# Value Engineering - Site Plan:

# Value Engineering - Roof:

# Value Engineering - Exteriors:

# Value Engineering - Interiors:

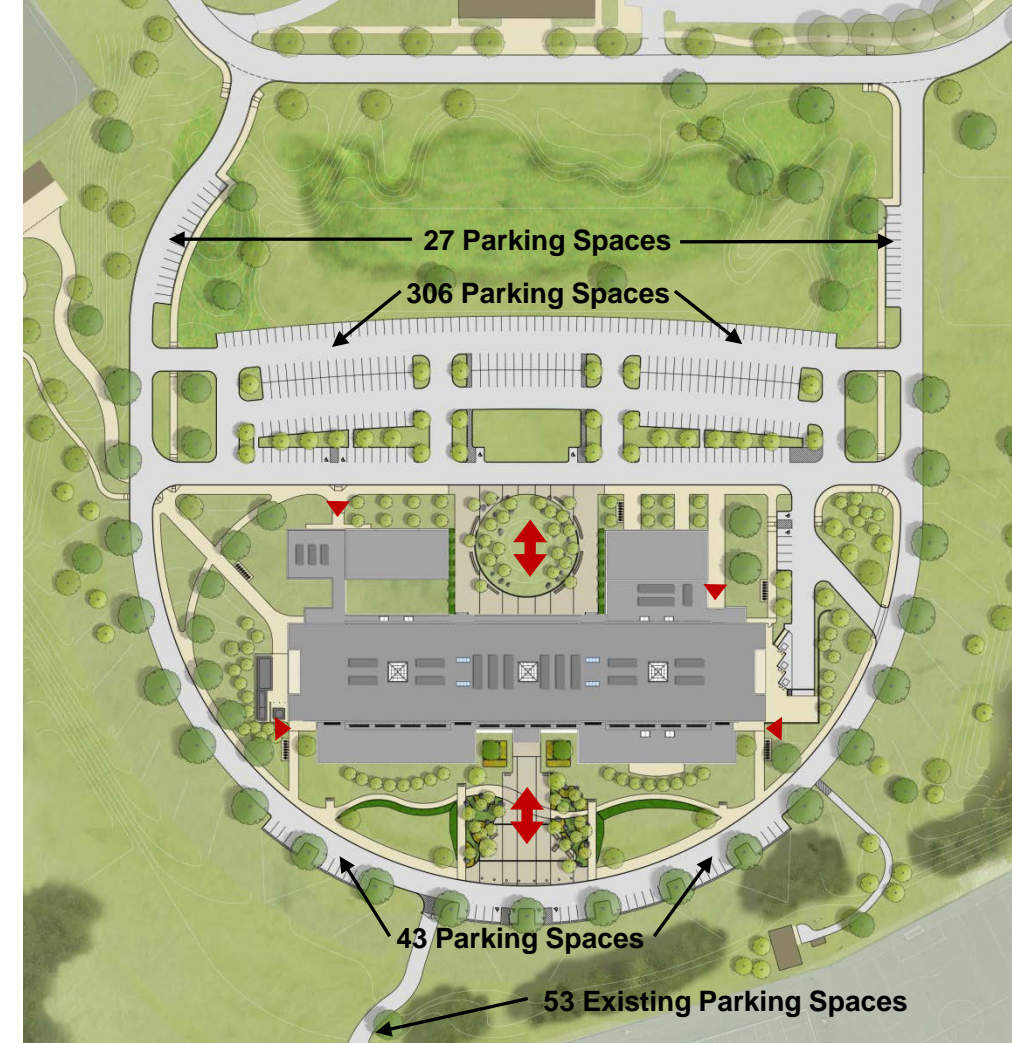
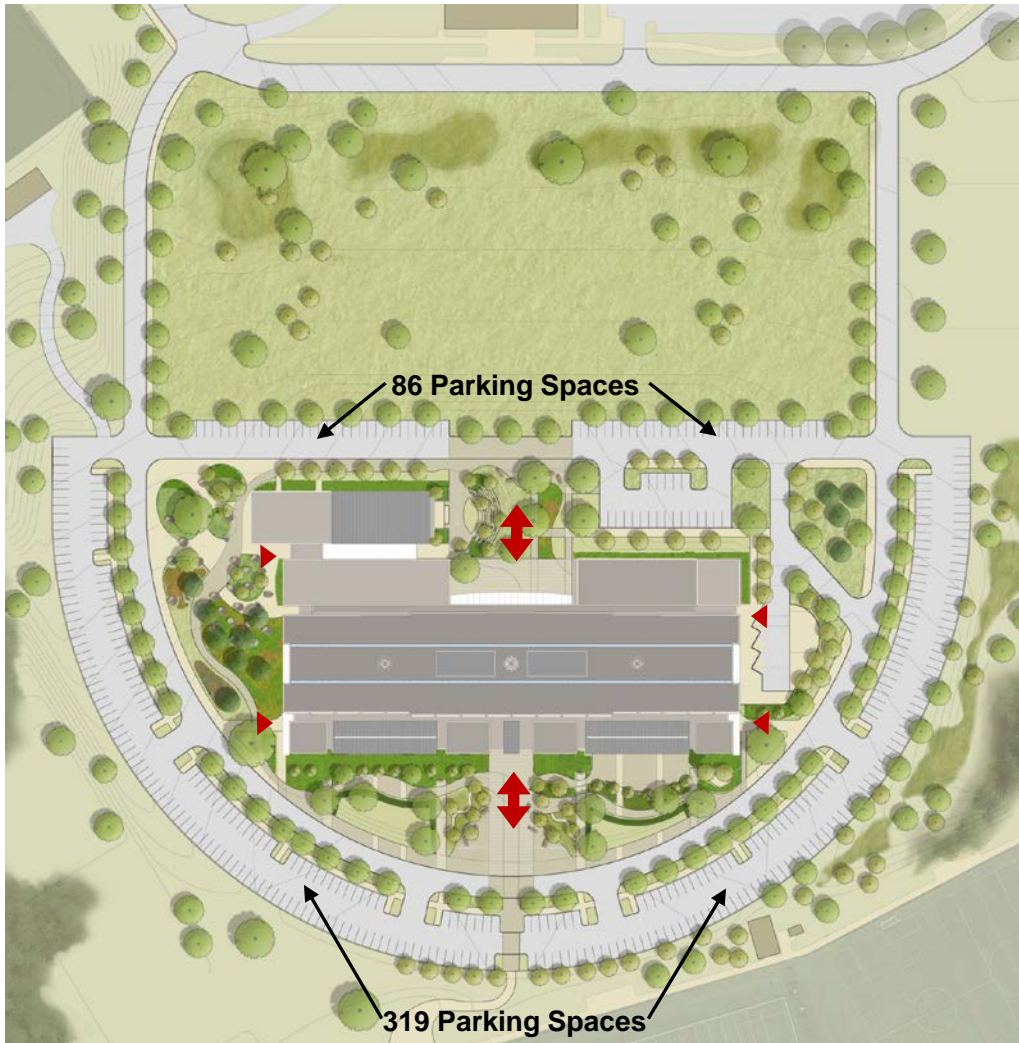
The site has less paving, more undisturbed green space and a greener water retention system. Utilities to the site have been reduced.

- 4416' new looped water line (SD-VE target to use existing)
- 1730' of new high pressure gas line
- 35 new catch basins
- 2778' of new sewer main piping
- 6 new water quality structures (SD-VE target for SWM Bio savings)

- 1/3 reduction in site hardscape, light bollards, and pavement
- 10% reduction in planting
- Delete irrigation system and add sleeves
- Reduce cut/ fill by dropping Building Elevation, soils and grading

- 1600' of new water line loop
- 2350' of new high pressure gas line
- 50 new catch basins
- 1462' of new sewer main piping
- 3 new water quality structures

- Water storage collection system for irrigation
- Additional post construction stormwater control

- Re-use existing water line loop
- 1430' of new high pressure gas line
- 15 new catch basins
- 1300' of new sewer main piping
- No water quality structures (utilize bio-retention areas)

- Delete outdoor amphitheater
- 376 new parking spaces and re-use 53 existing spaces

- Reduction in site hardscape, bollards, and pavement
- Reduction in planting
- Delete irrigation system and add sleeves
- Reduced cut/fill and grading
- No water storage collection system

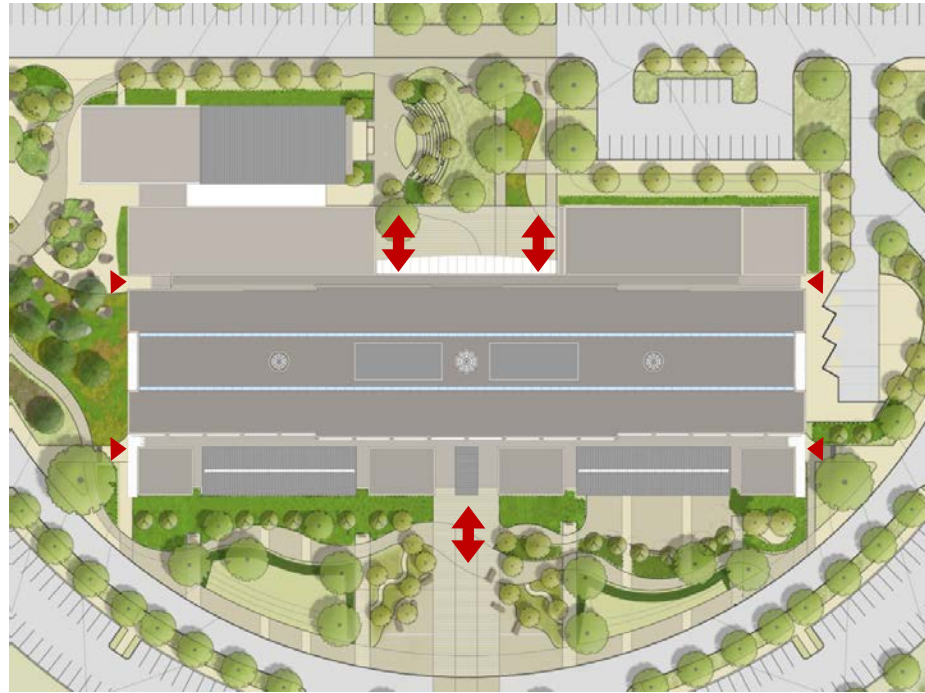
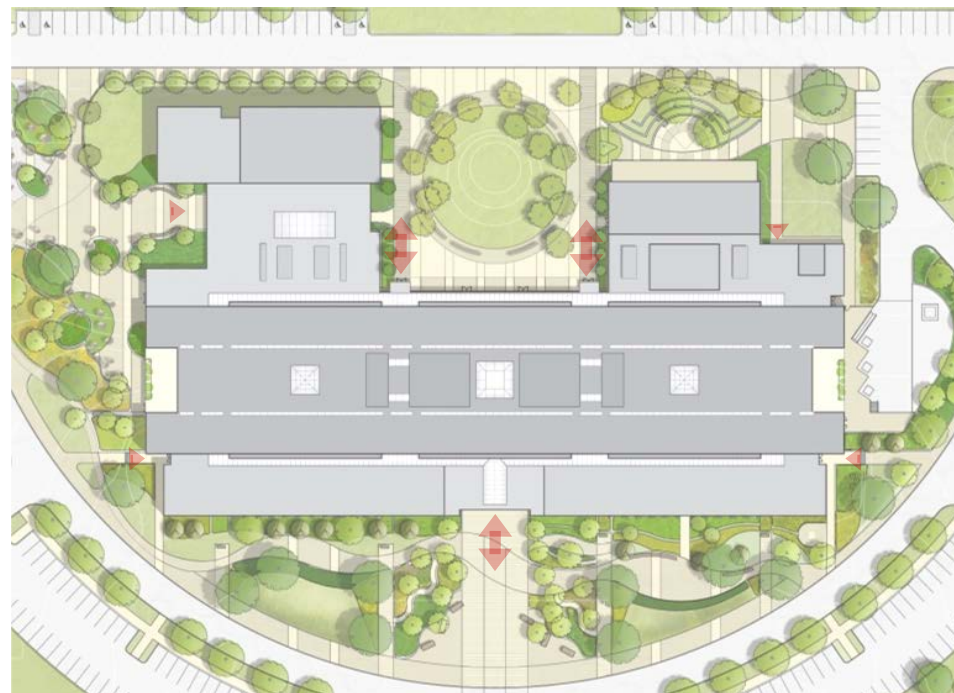
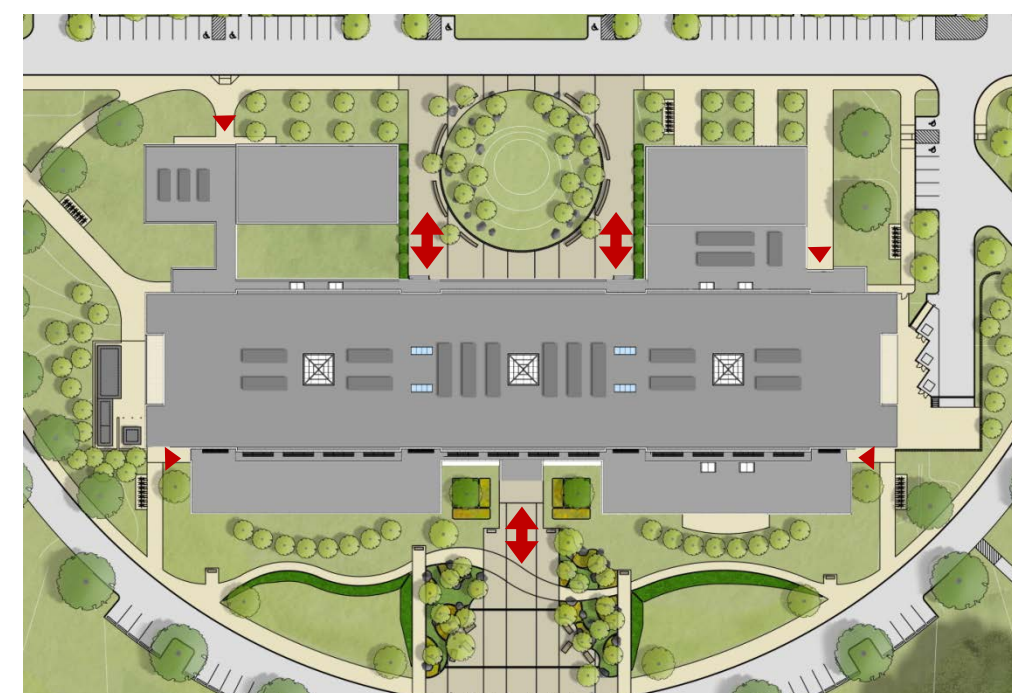
Roofs/ Roof Structures/ Skylights: Everything has been made more straight forward, simpler and less expensive while maintaining high performance standards.

- Skylights at stairs
- 2 roof penthouses (boiler and chiller)
- No roof screens

- Targeted roof savings (materials, details and delete curved roofs)
- Targeted savings to reduce design of 3 cupolas at light wells
- 1/3 reduction in continuous skylights at light shafts

- 8 skylights at stairs
- 2 roof top penthouses (boiler and chiller)
- Mechanical roof screens

- TPO roofing and no curved roofs
- 3 skylights at light wells
- 1/3 reduction in continuous skylights at light shafts

- 6 skylights at stairs
- 1 roof penetration (boiler)
- No roof screens

- PVC roofing and no curved roofs
- 3 skylights at light wells
- Eliminate continuous skylights and light shafts but retain daylighting to classrooms from corridor side via light wells (Energy model improved)
